C4 CHANGES

BUILDING 401
MANCHESTER AIRPORT

BUILDING 401
PROPOSED DRAINAGE
SHEET 1 OF 2

60663052-ACM-401-XX-DR-C-52014

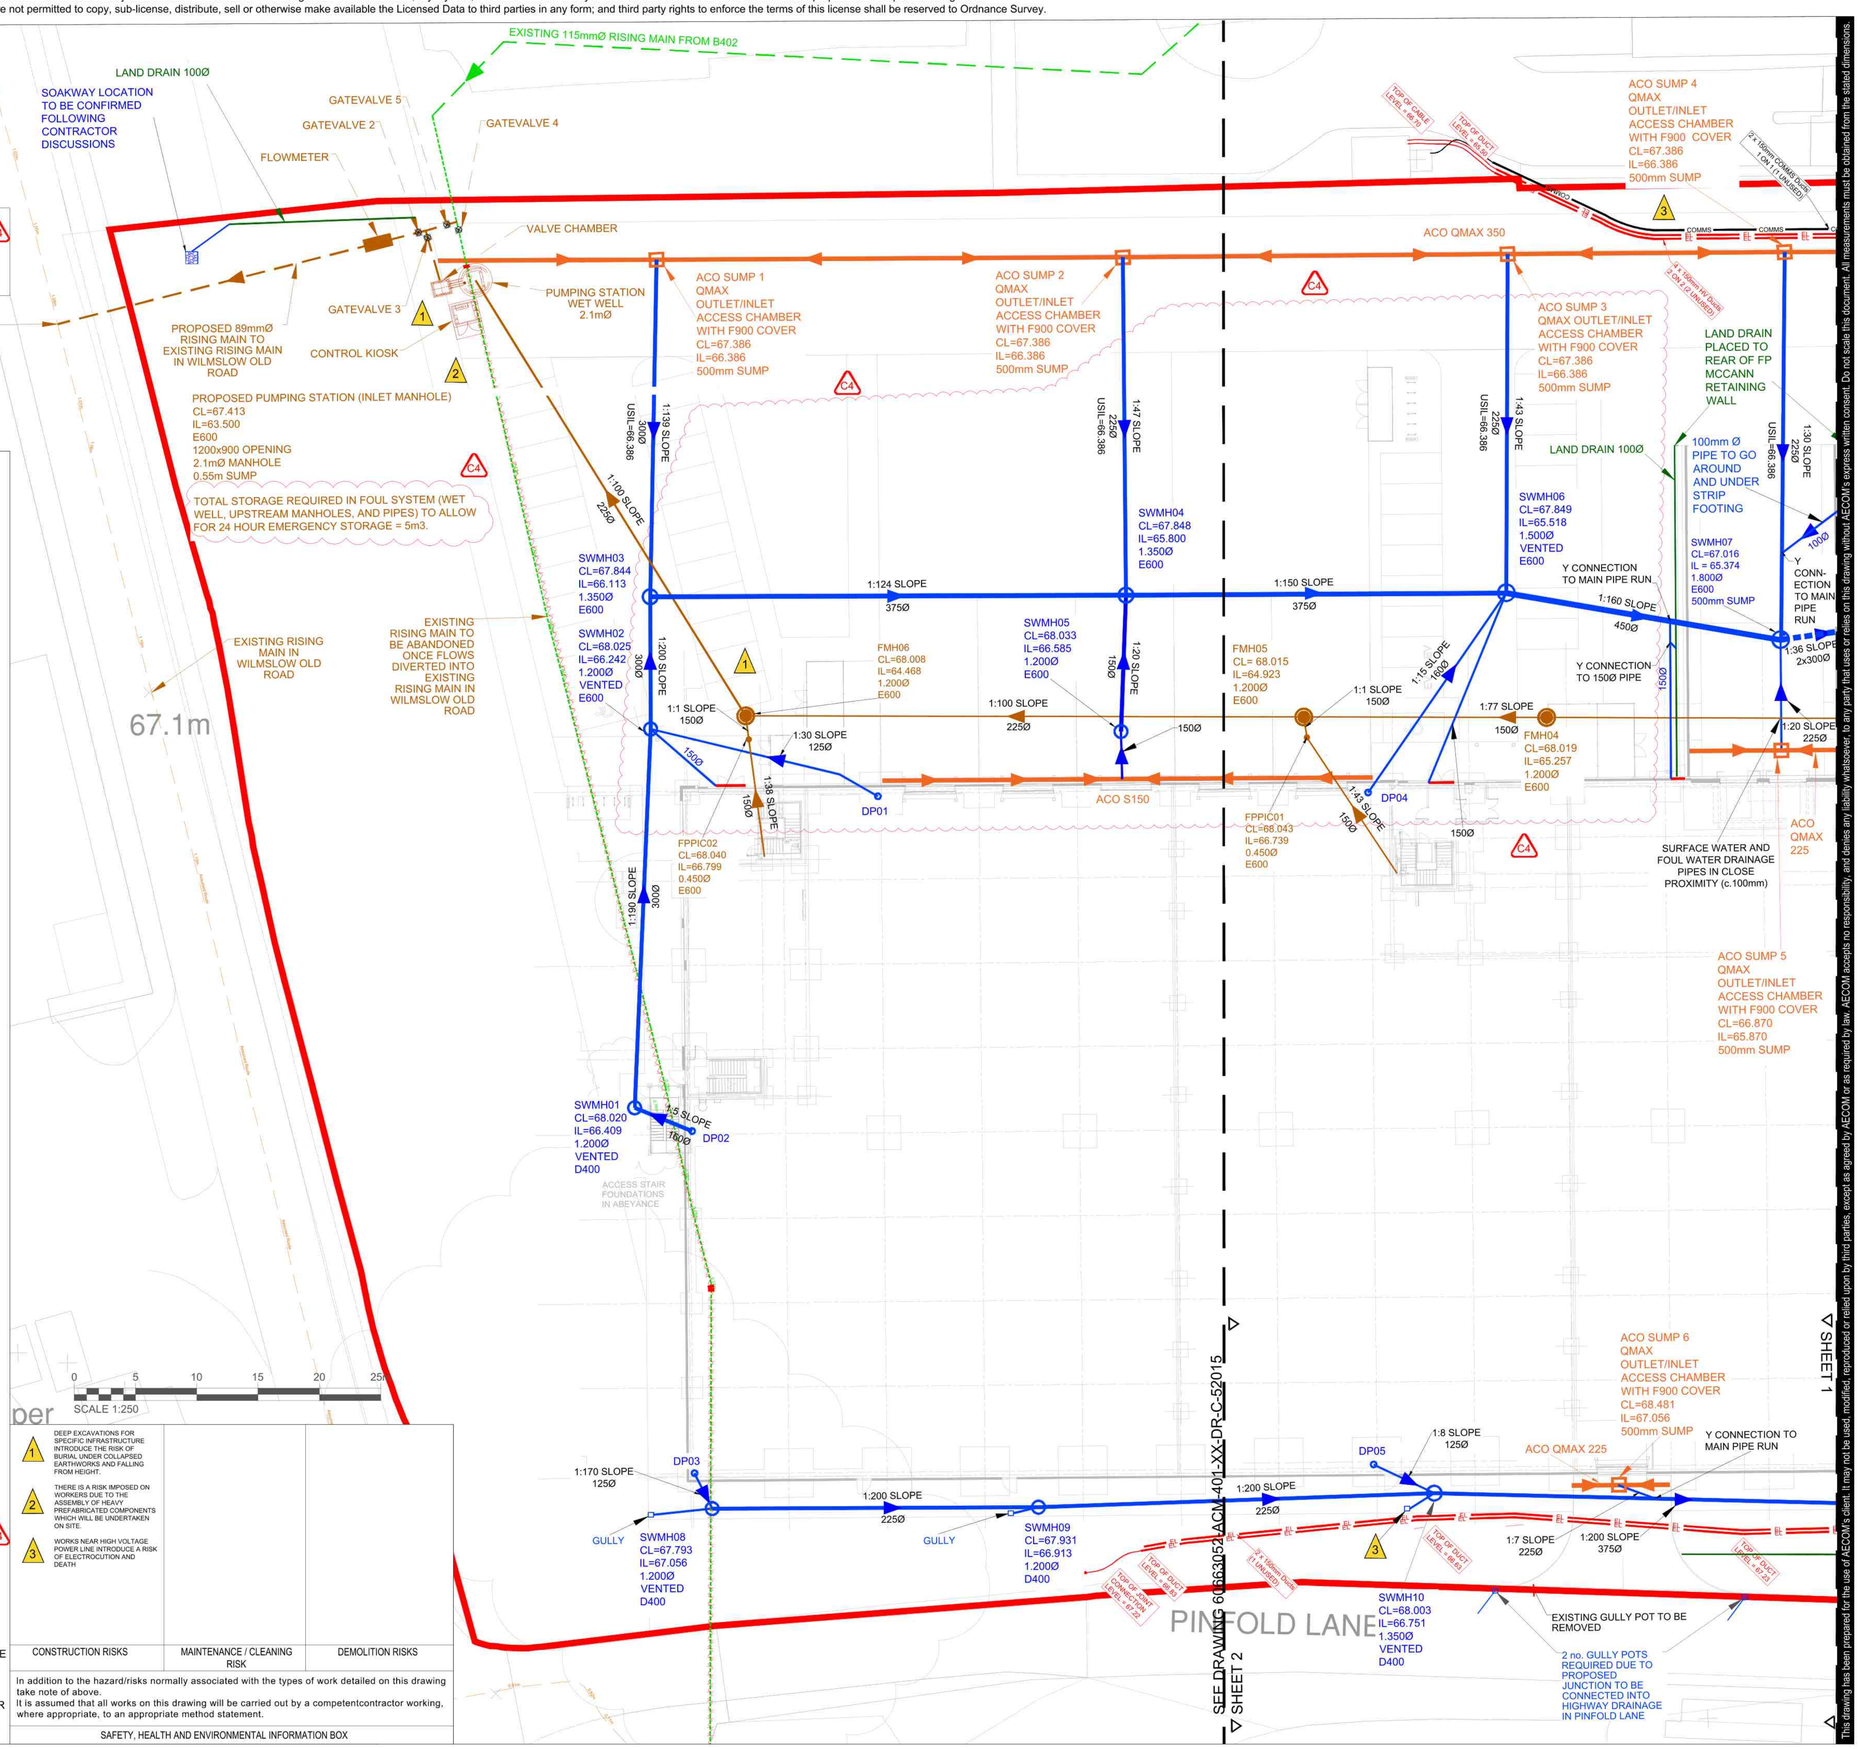
1. FOUL NETWORK SERVING REFUSE AREAS REMOVED AS NO LONGER REQUIRED.
2. SEE NOTE 24.
